Re: PLN-21-471 – Review of Advertised Documents – Flooding and Stormwater –

pitt&sherry have been engaged by City of Hobart (Council) to undertake a technical review of the flooding and drainage material provided from the proposed development at 173 – 179 Campbell Street Hobart (PLN-21-471).

Figure 3: Flood evacuation timeline (Figure 2: Australian Disaster Resilience Manual 20: Flood Preparedness, 2009, Australian Institute for Disaster Resilience CC BY-NC)

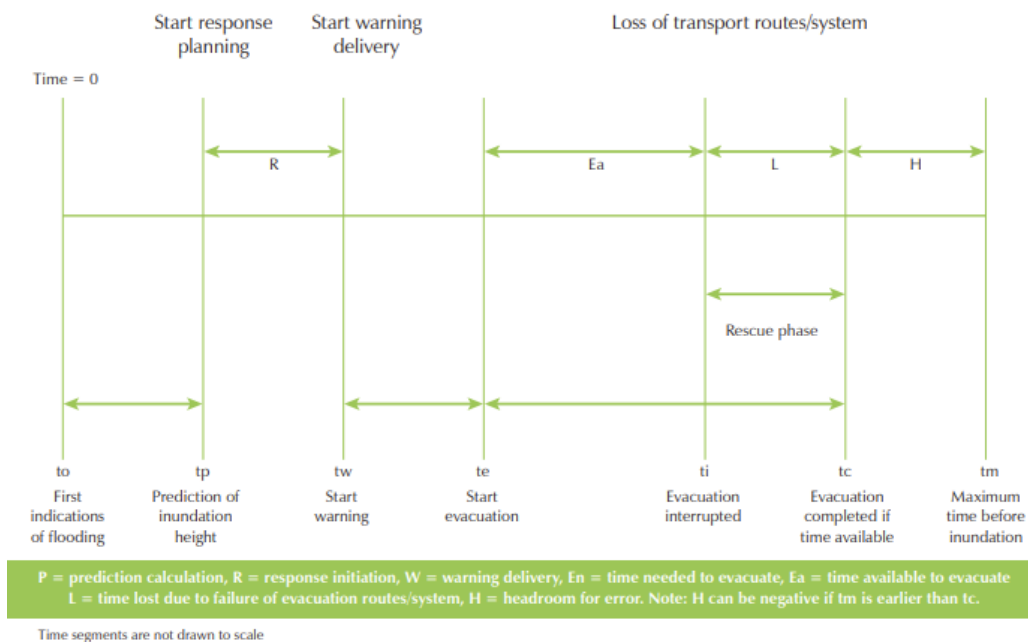
- Figure 3 shows an excerpt from the Australian Disaster Resilience Manual 20 and presents an example evacuation timeline. For this example, only the first four steps are relevant. For a FEMP to work, the time between the first indication of flooding and the prediction of inundation height, plus the response initiation time must be less than the time where flood water first becomes hazardous (noting this is less than 9.5 minutes). There has been no discussion in the material provided on evacuation timeline.
